**THE COTTAGES AT MESA RIDGE  
PUD/ PRELIMINARY PLAN**  
A PORTION OF THE NORTHEAST QUARTER OF SECTION 29, THE SOUTHEAST QUARTER  
OF SECTION 20, THE SOUTHWEST QUARTER OF SECTION 21, & THE NORTHWEST  
QUARTER OF SECTION 28 TOWNSHIP 15 SOUTH, RANGE 65 WEST OF THE 6TH P.M.  
COUNTY OF EL PASO, STATE OF COLORADO

# PUD Development Plan\_V2.pdf Markup Summary 2-14-2022

SHEET SP 4

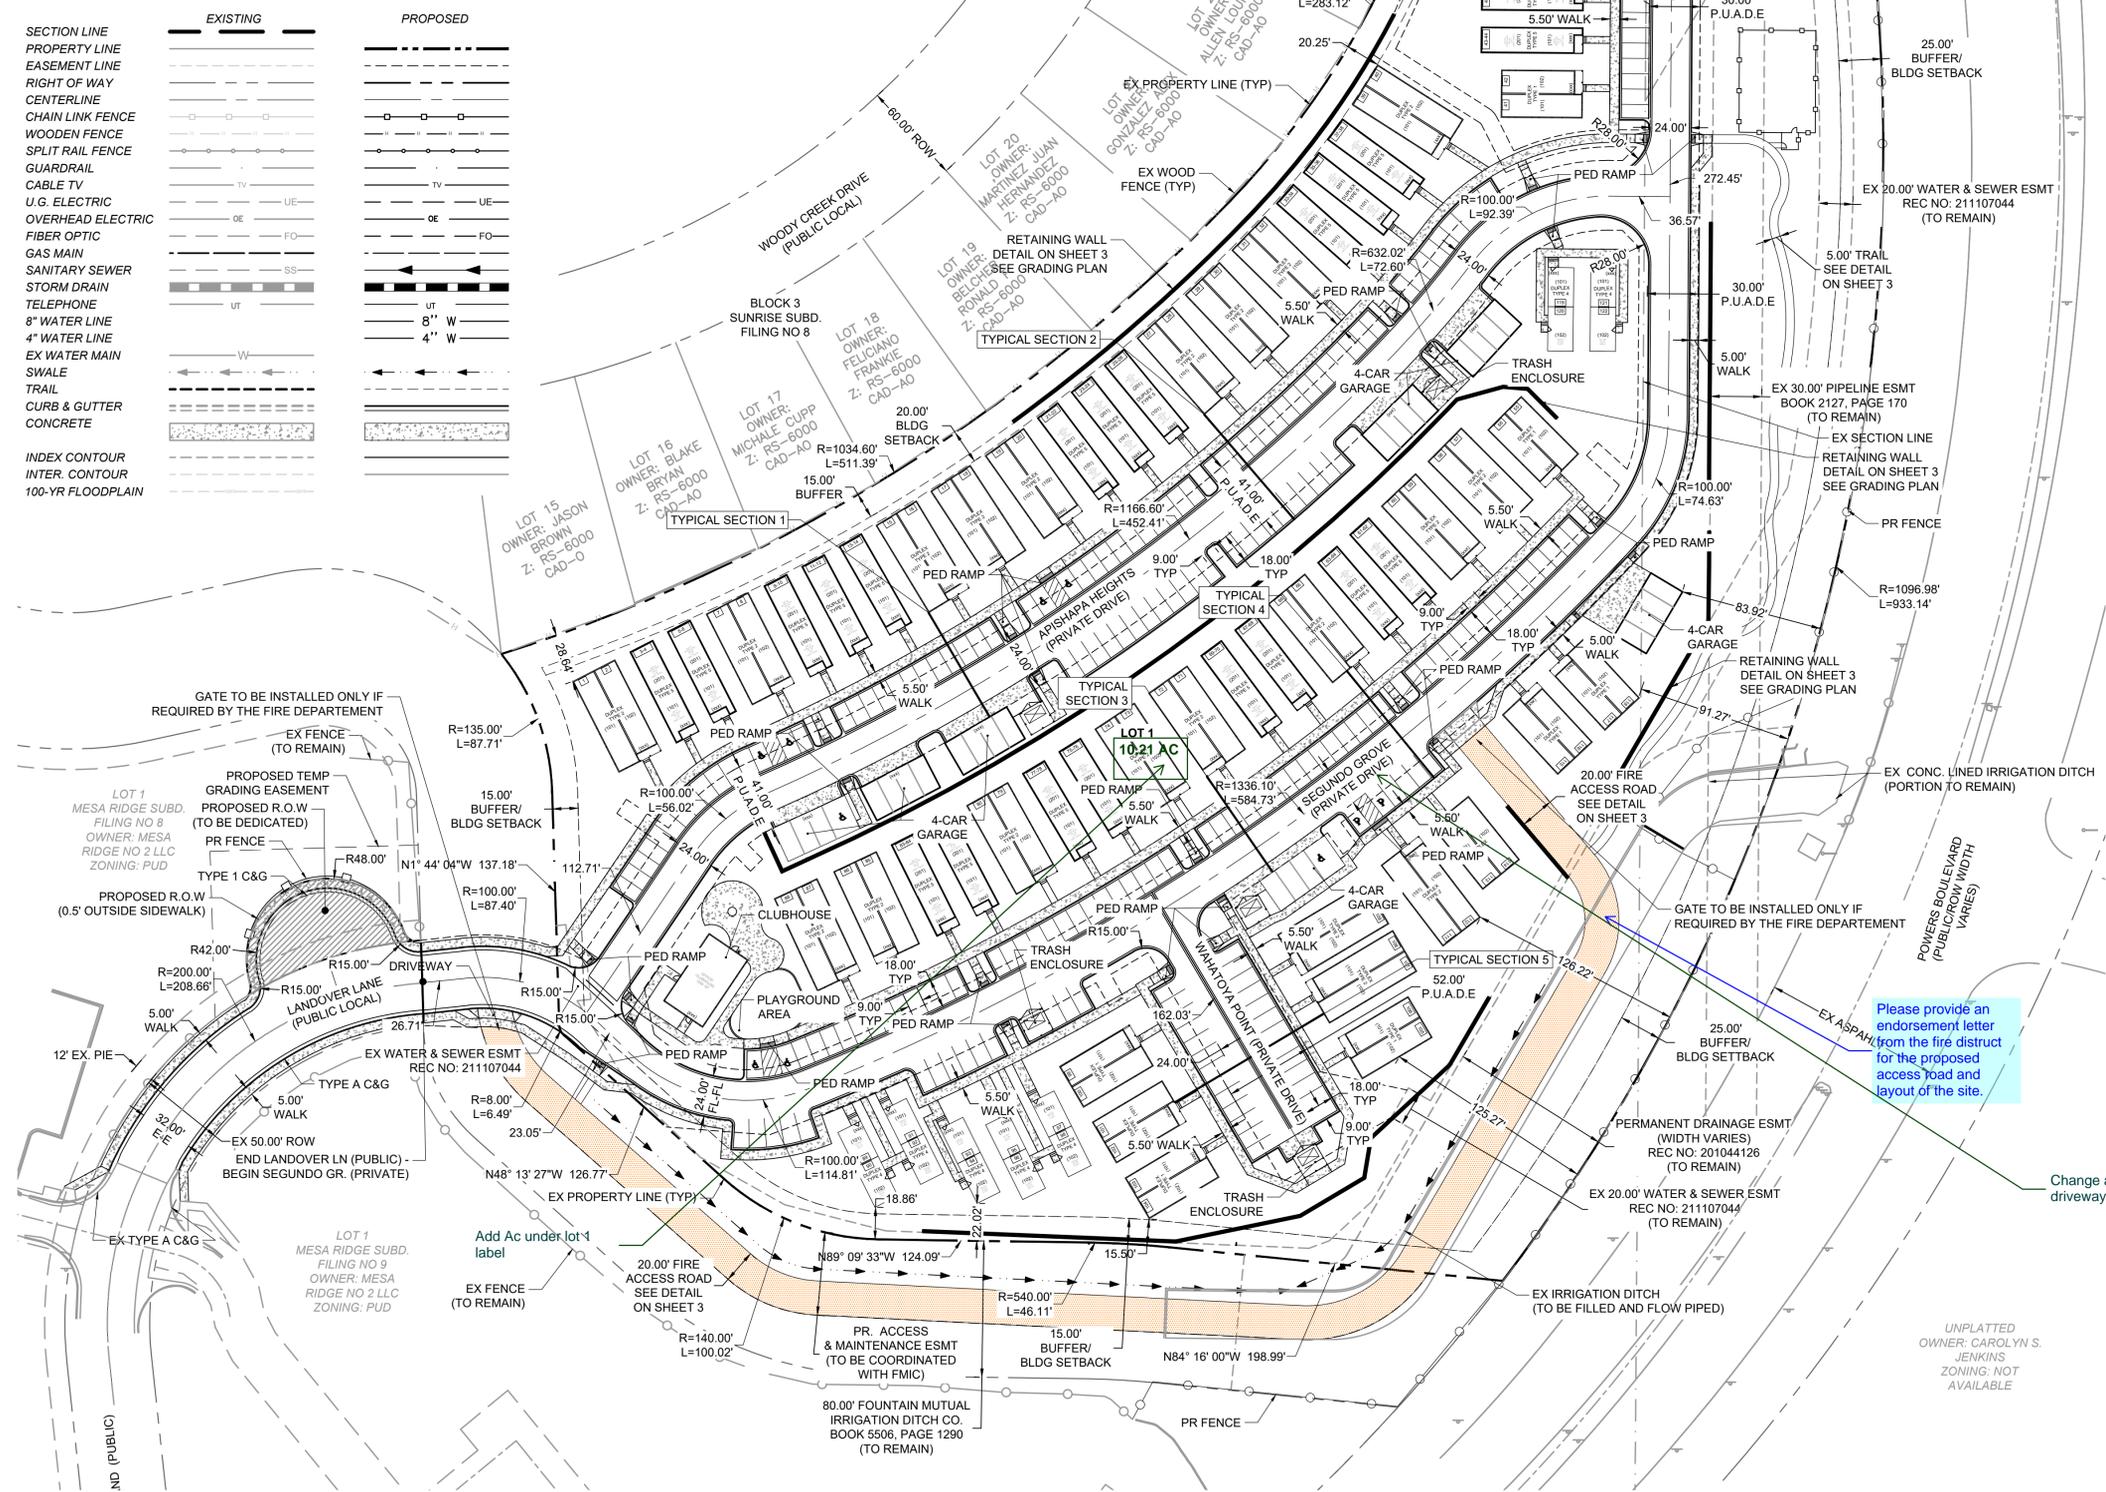
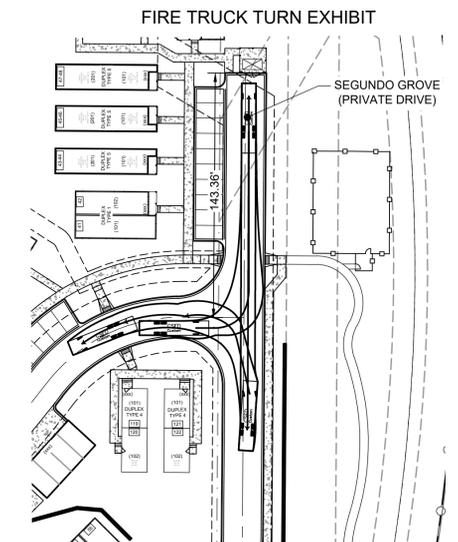
Please provide an endorsement letter from the fire district for the proposed access road and layout of the site.

Change all "drive" to "driveway"

this should be Sheet 2...[is]the heart of the PUD plan set

CRAFTSMAN ELEVATION

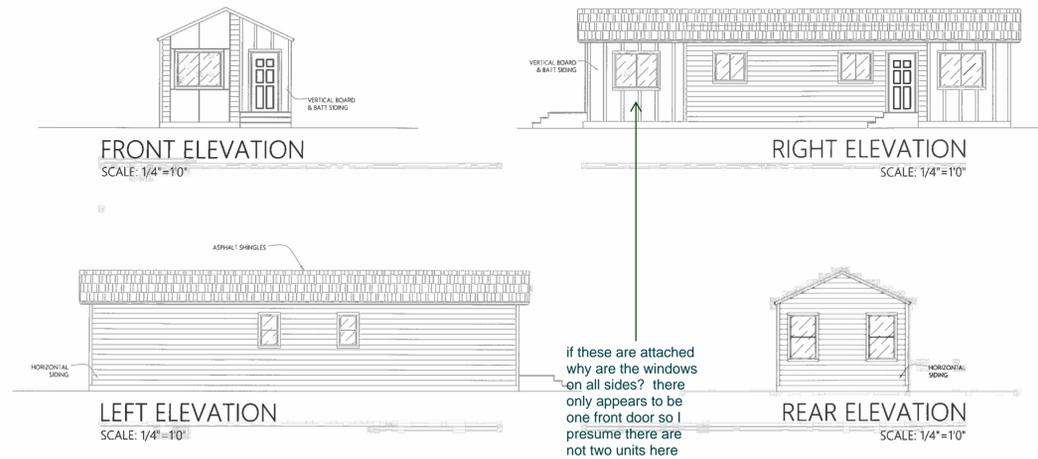
label these so the match the elevation names

Can you label the units front door - these look like a single family unit not two-family.

FARMHOUSE ELEVATION

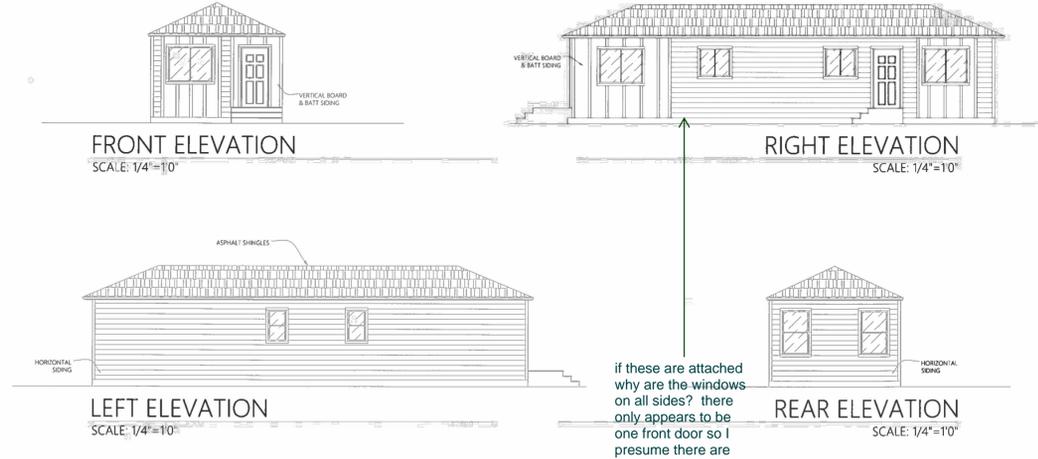
Can you label the units front door - these look like a single family unit not two-family.

MODERN ELEVATION

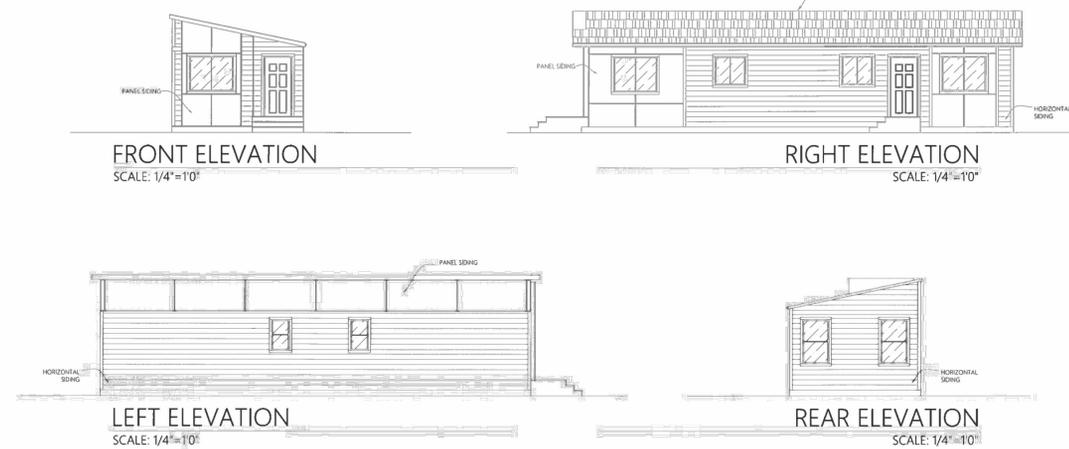
Can you label the units front door - these look like a single family unit not two-family.
